**REPORT TO THE
MINISTER FOR ENVIRONMENT**

**APPEALS IN OBJECTION TO THE CONTENT OF, AND RECOMMENDATIONS
IN, AN ENVIRONMENTAL PROTECTION AUTHORITY REPORT**

**EPA REPORT 1574: YEELIRRIE URANIUM PROJECT
SHIRE OF WILUNA**

PROPONENT: CAMECO AUSTRALIA PTY LTD

Figure 3 – Yeelirrie PEC

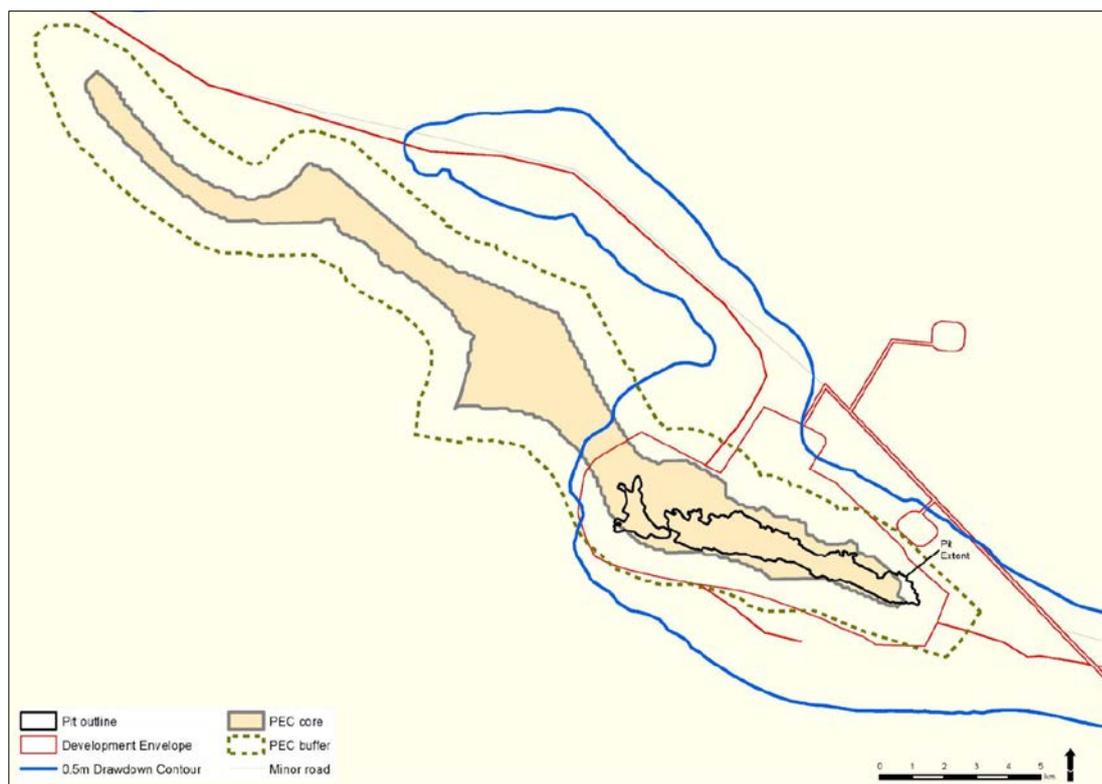
In relation to the extent of stygofauna habitat, the proponent noted the EPA's acceptance that the boundary of the area as being the *Yeelirrie calcrete groundwater assemblage type on Carey palaeo-drainage on Yeelirrie Station* Priority Ecological Community (PEC), as shown in Figure 3.

The proponent contended that there was no logical basis to infer the habitat within the PEC is unconnected:

In fact, the heterogeneous nature of calcrete habitat, its propensity for voids and the high species richness of the PEC should have led the EPA to infer the existence of available pathways, rather than to presume that all habitat expressions are constrained by physical or chemical barriers.
